## Attachment 4

### Summary of Consultation with Internal Council Staff and Independent Consultants

#### 6-8 Colden Street and 62-64 Menangle Street, Picton, NSW 2571 Planning Proposal

DEPARTMENT	DATE OF RESPONSE	COMMENTS	ASSESSMENT RESPONSE
		<p>  Study Area   TUFLOW Hydraulic Model Extent for PMF   Railroad  <b>Flood Planning Constraint Category</b>   FPCC 1   FPCC 2   FPCC 3   FPCC 4 </p>

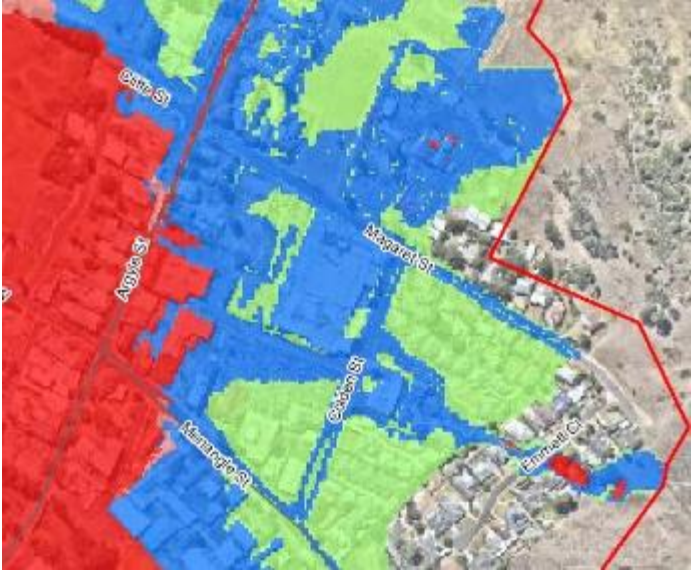
DEPARTMENT	DATE OF RESPONSE	COMMENTS	ASSESSMENT RESPONSE
		<p>associated with a valley system that approximately aligns with Keable Close to the east.</p> <p>This corresponds to the extent of flooding during the 1% AEP event and the Flood Planning Level is set with a freeboard of 300mm above the water surface. The overland flooding is variable across the site but relatively shallow and the freeboard will raise the Flood Planning Level more than the flooding itself.</p> <p>The lighter hatching to the east of the Site represents the Mainstream Flood Planning Area for flooding associated with Stonequarry Creek itself. This is the area where land is below the Flood Planning Level of 500mm above the 1% AEP Flood Level. It appears that the site is not affected by the Mainstream Flood Planning Area.</p> <p>Larger floods are possible and the Mainstream PMF dominates with the flood level significantly (several metres) above the Site ground level.</p> <p>The flood behaviour has been used to come up with a Flood Planning Constraint Category definition for the floodplain with the adopted Floodplain Risk Management Plan.</p> <p>The mapping is shown below where the Overland Flood Planning Area corresponds to FPCC 3 while the remainder of the site is FPCC 4.</p>	<p>The need for a flood impact assessment at the DA stage is acknowledged and recommended. The PP and Preliminary Flood Assessment has been reviewed by Council's Engineering Department. This assessment is supportive of the PP and concludes that the proposed building height increase does not have any implications from a flood perspective.</p> <p>The PP has been assessed against the relevant Section 9.1 Ministerial Direction relating to Flood Prone Land. The proposal does not rezone the site nor alter the uses that are permitted within the B2 Local Centre zone. As such, the proposal does not permit a significant increase in the development of the site. The PP is therefore consistent with the relevant ministerial direction relating to flood prone land.</p> <p>On the basis of the above assessment, it is considered that a flood impact assessment would need to be undertaken to support any future DA for the site. In addition, it is recommended that the site specific DCP include appropriate flood planning controls. This may include the establishment of an appropriate freeboard at ground floor level within the site and wider CCCP.</p>

DEPARTMENT	DATE OF RESPONSE	COMMENTS	ASSESSMENT RESPONSE
		<p>The application of FPCCs requires a revision of the DCP to reflect the new classification – a process that has commenced but not sufficiently advanced to be of assistance at this point.</p> <p>As stated in the Preliminary Flood Assessment by WMAwater, the subsequent development proposals will need to address the challenges of the flood behaviour at the Site but the increased building height itself does not have any implications from a flood perspective.</p>	
Open Space	26/11/20	Council's Open Space Team provided general support for the proposal. With regards to planting and landscaping, it was noted that consideration should be given to the position of tree planting in close proximity to the underground parking.	This is a matter that would be addressed at DA stage. Notwithstanding, controls pertinent to landscaping, deep soil and tree protection could be included within the recommended site specific DCP for the site and wider precinct.
